November 5, 1993

SUBJECT: Response to FDEP Request for Information
Regarding: Operating Permit Application Renewal
Permit No. UO 56-237554
North Port St. Lucie Injection Well IW-1

On behalf of St. Lucie County Utility Services Department (SLCUSD), Montgomery Watson is pleased to submit three copies of the response to the Florida Department of Environmental Protection (FDEP) Request for Information (RFI) regarding Operating Permit Application for Injection Well IW-1 at the North Port St. Lucie Injection Well System, Permit No. UO 56-237554, dated October 8, 1993.

GDU North Port St. Lucie WWTP—Summary of Well Construction and Hydrogeologic Data. **FIGURE 2-3.**

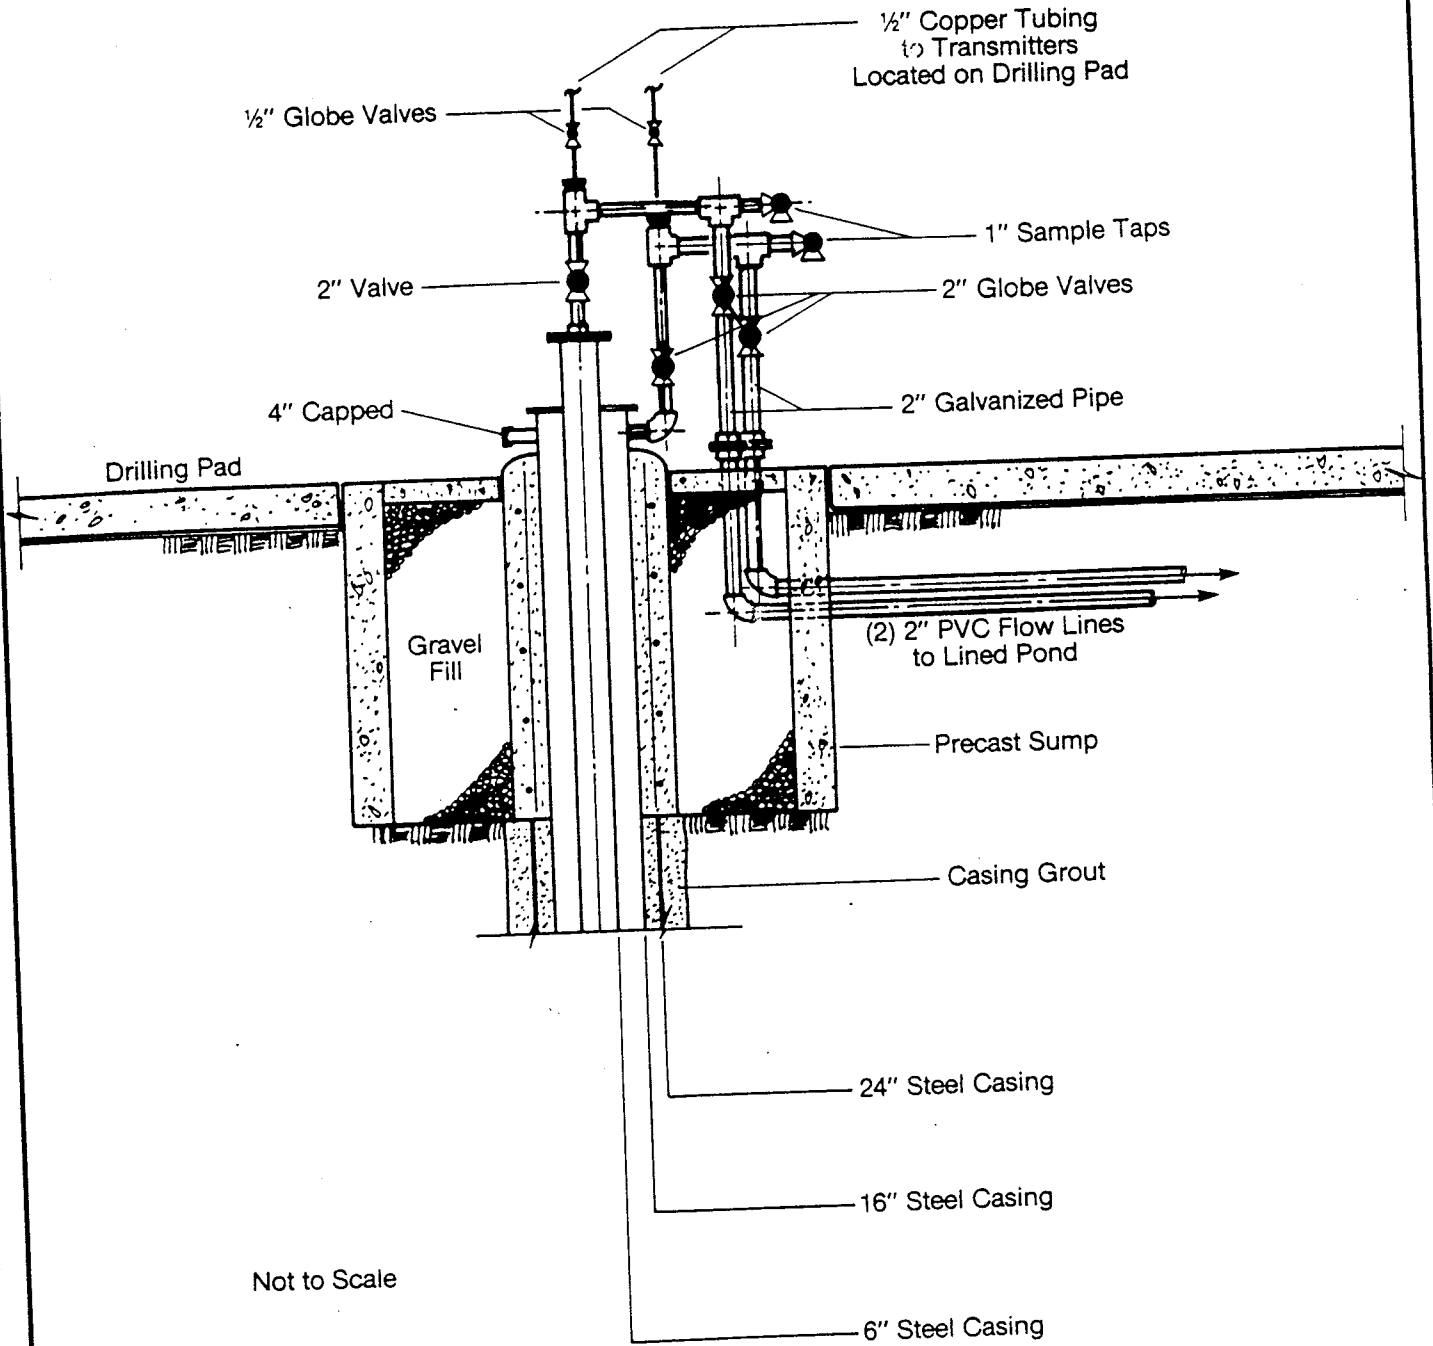
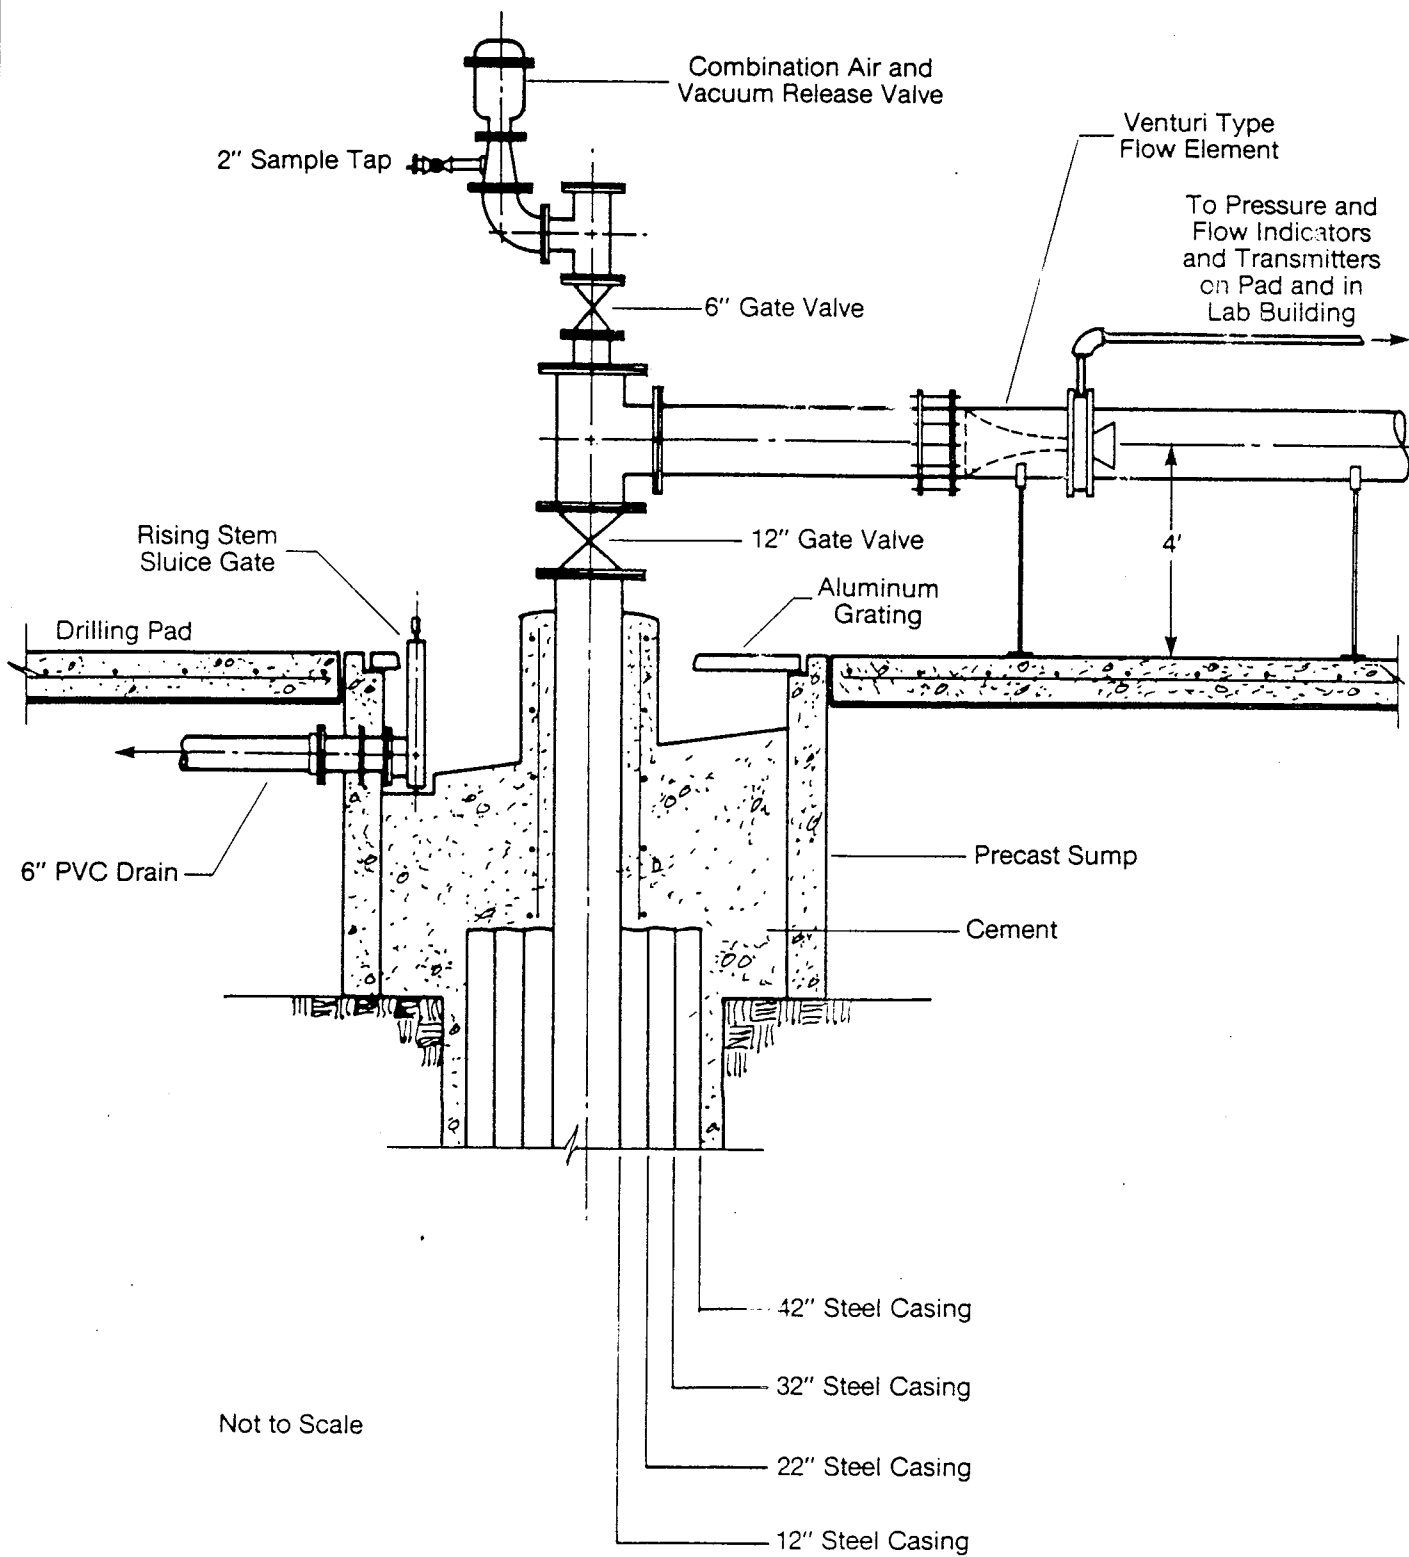
5. **As required by Rule 17-28.340(1) (c) 2, F.A.C., an "as-built" drawing for the injection well and monitor well must be submitted for the operating permit application. The as-built drawings must be to scale, signed and sealed by an engineer and include casing thickness, depths,**

diameters (OD or ID identified) and identify the stratigraphic units intersected by the wells.

A copy of the "as-built" drawing for the injection well and monitor well, as submitted for the original operating permit application, has been included in Attachment F.

(Describing locations of an existing INJECTION WELL and an existing MONITORING WELL at the North Port, Port St. Lucie, Wastewater Treatment Plant lying West of St. James Drive in Section 20, Township 36 South, Range 40 East, St. Lucie County, Florida.)

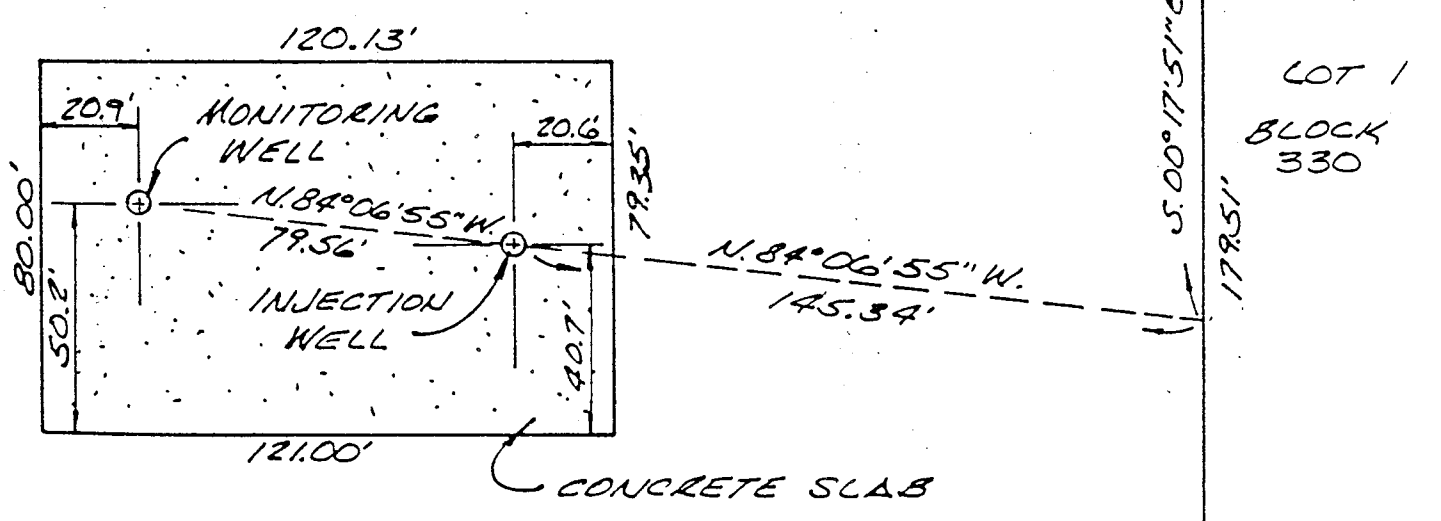
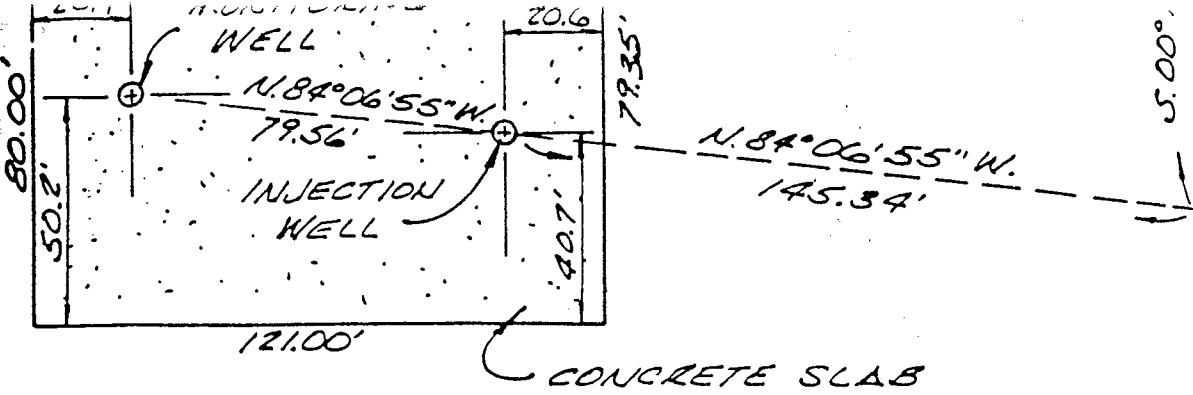
- 6. As required by Rule 17-28.340(1) (c) 2, F.A.C., a record drawing of the location of the injection well in reference to the monitor well, to scale and with the north direction indicated, is needed for the application to be complete.**

A copy of the record drawing for the location of the injection well and monitor well, as submitted for the original operating permit application, has been included in Attachment H.
